Work Order ID 87578

Item Name: Energy Attenuating Floor Provisions

DART SERVICE INSTRUCTION

TO AMEND INSTALLATION INSTRUCTIONS IIN-D350-689 REV. B
AND INSTRUCTIONS FOR CONTINUED AIRWORTHINESS ICA-D350-689 REV. 1

FIGURE 1: UPDATES TO FIGURE 21 (IIN-D350-689) AND 25-21 (ICA-D350-689)

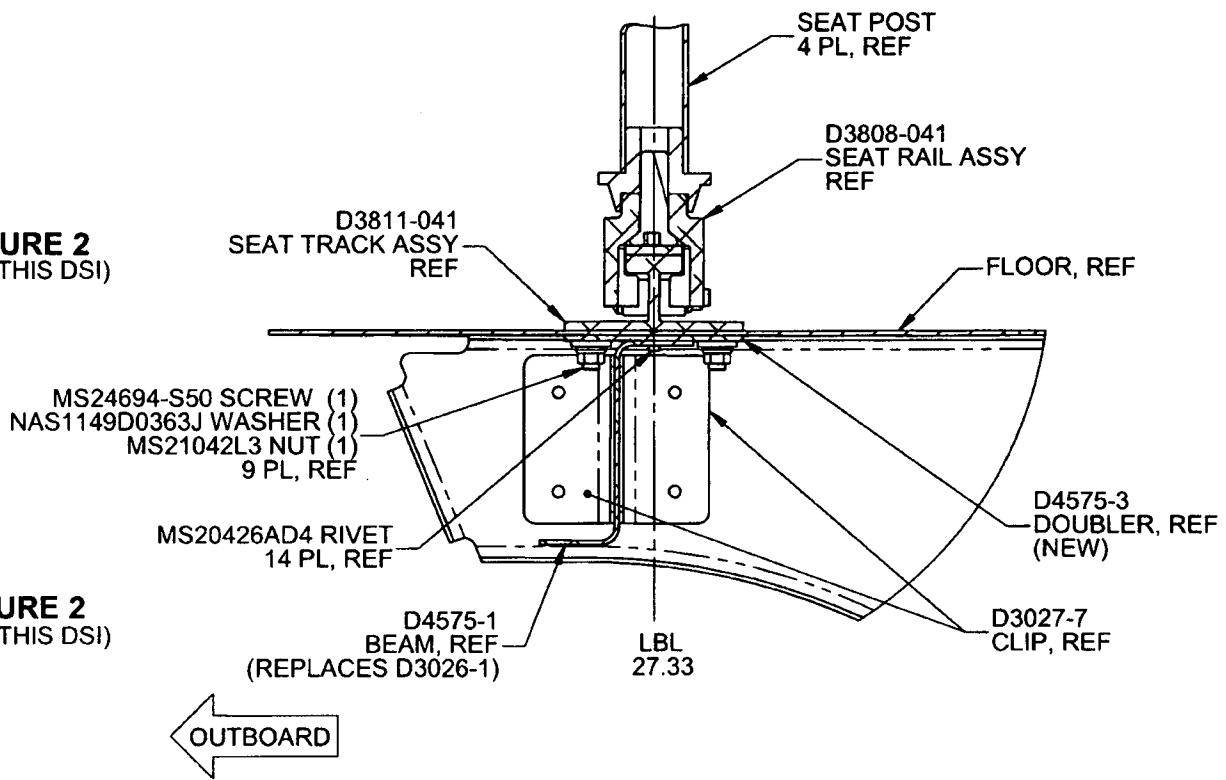
For D350-689-021-023 Kits at CHG 005/004 and later, the D3026-1 Channel has been replaced with the D4575-1 Beam and D4575-3 Doubler and the D3234-3 Doubler has been removed. Consequently, the installation instructions for D350-689-021-023 at CHG 005/004 are updated per Section 2.0 of this Service Instruction. The parts list update is shown in Section 4.0 of this Service Instruction. There is a negligible change to the weight and balance.

If there is an existing stringer at LBL 27.33, it will need to be removed from that location. Locate D4575-1 Beam and D4575-3 Doubler as shown in Figure 1 of this Service Instruction. Transfer drill existing holes from the aircraft floor to the D4575-1 Beam and D4575-3 Doubler. Ensure 1.0" to 1.5" rivet pitch and add additional holes if required. If there is no existing stringer, locate D4575-1 Beam and D4575-3 Doubler as shown in Figure 1 of this Service Instruction and drill Ø0.128" holes on a 1.0" to 1.5" pitch.

FIGURE 2: RELIEFS ON D4575-1/3
(ONLY D4575-1/3 SHOWN FOR CLARITY)
VIEW LOOKING INBOARD

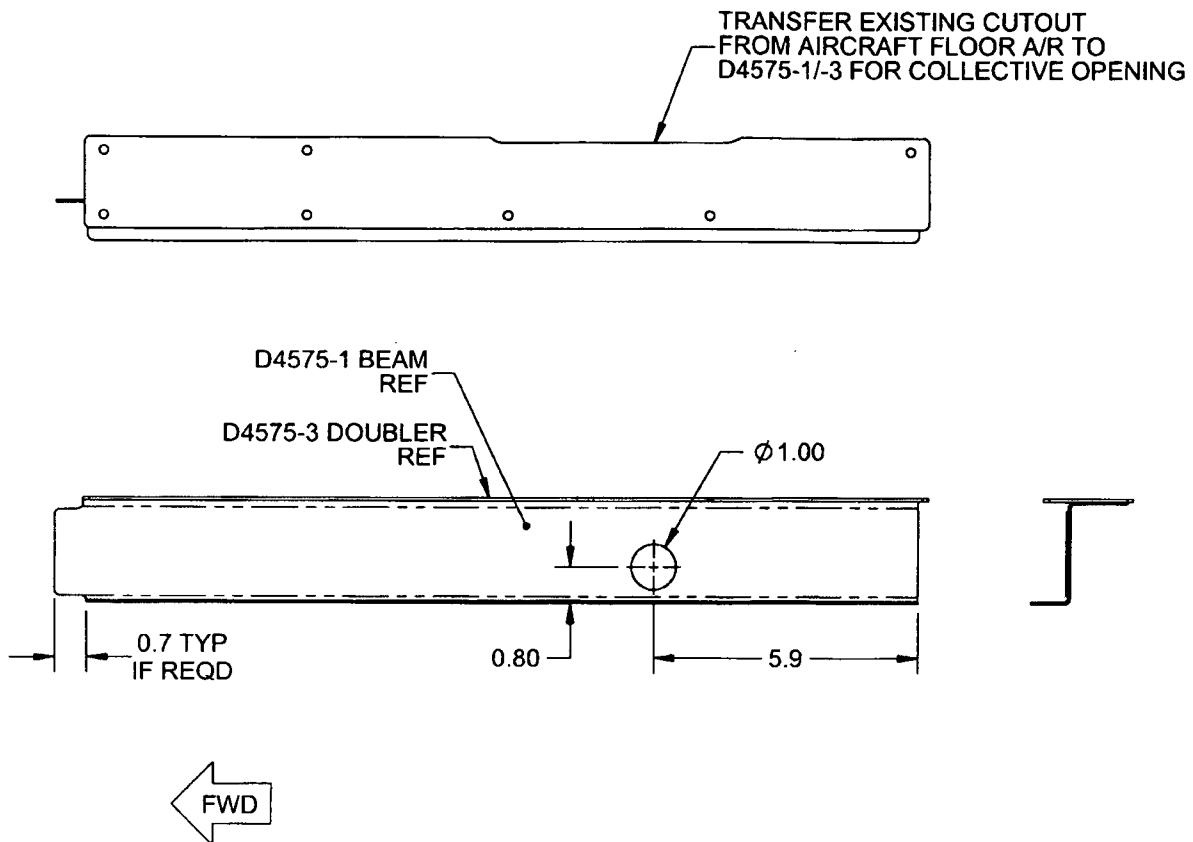
Note: Drill a Ø1.00" (Ø25.4 mm) hole in the D4575-1 Beam to clear extension tube of collective and cutout as required for clearance of collective opening and fwd bulkhead as shown in Figure 2 of this Service Instruction.
